TECHNICAL BULLETIN No. 0118

New OK TO PUMP THROTTLE READY Panel Plate

IL2965

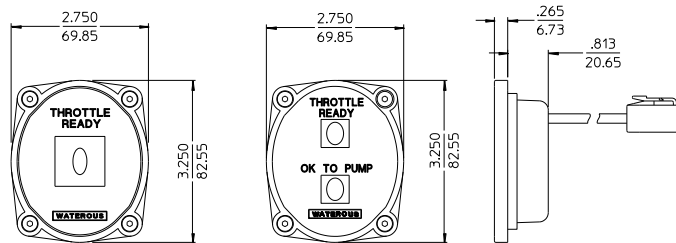
Orders received after June 1, 2016 will have the new Dual Light OK TO PUMP / THROTTLE READY Panel Plate (P/N 63805) which replaces the Single Light THROTTLE READY Panel Plate (P/N 63334).

This change is due to the NFPA 1901,2016 Edition, Section 16.10.2.1.2.

The figure below shows both the Single Light and Dual Light. Both panels use the same panel cut-out dimensions but have different wiring as shown on page two.
